UNITED STATES PATENT AND TRADEMARK OFFICE

10/518,205

Office Action Summary	Application No. 10/518,205	Applicant(s) NEERINCX ET AL.	
	Examiner ROBERT K. NICHOLS II	Art Unit 3754

DETAILED ACTION

Marked-up Figure 2

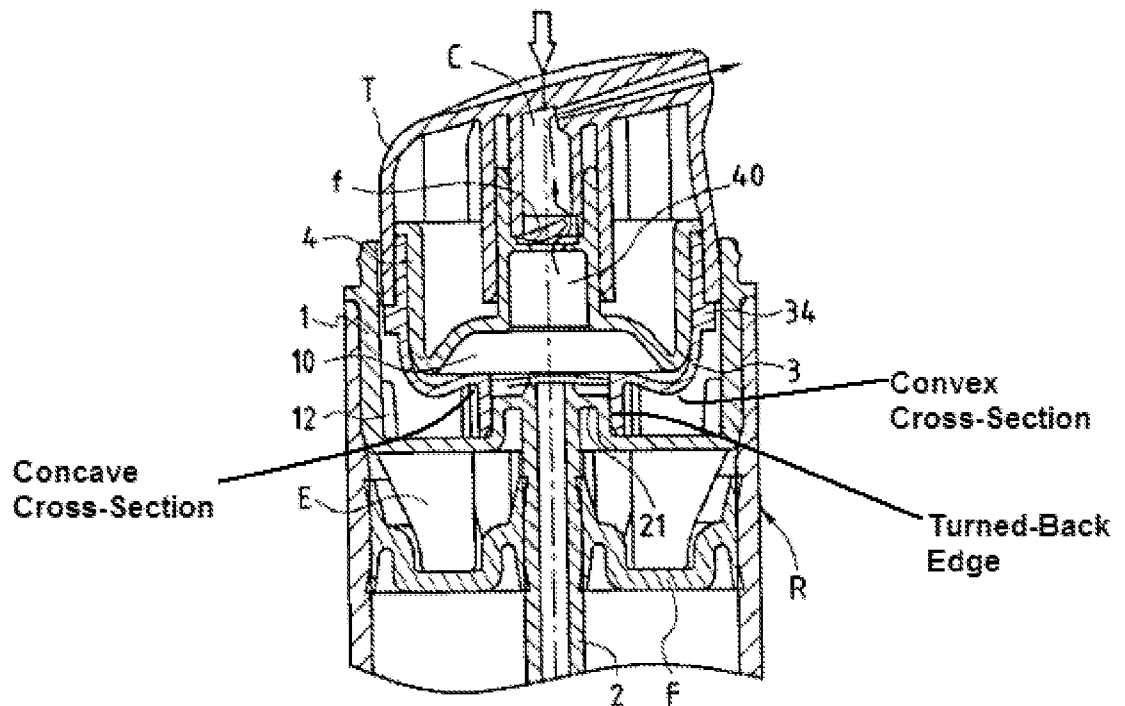
Regarding claim 3, Rossignol discloses the flexible wall 3 being partially turned back and wherein a turned-back edge is arranged on an outer end thereof (see marked-up figure 2).

Regarding claim 9, Rossignol discloses the outer wall of the flexible wall 3 includes a part of concave cross-section (see marked-up figure 2).

Regarding claim 10, Rossignol discloses the outer end of the flexible wall 3 includes a part of convex cross-section (see marked-up figure 2).

Regarding claim 14, Rossignol discloses the wall of the bellows part includes a substantially convex cross-section (see marked-up figure 2).
